River District Master Street Plan (2020 Update)

*Advance Materials for the January 14th, 2020
Planning and Sustainability Commission Hearing*

Proposed Update to River District Master Street Plan

Proposed

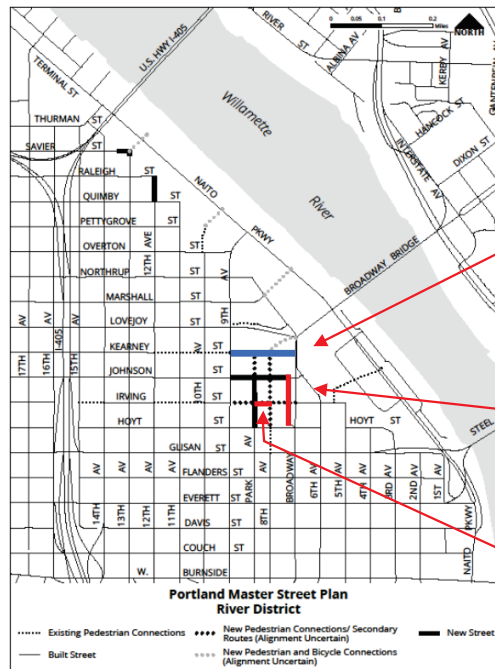
Modify the Master Street Plan designation of NW Kearney St through the USPS Master Plan site from “New Pedestrian Connection” to “New Street”

Remove the frontage road along Broadway Blvd

Remove Irving St segment through the new North Park Block
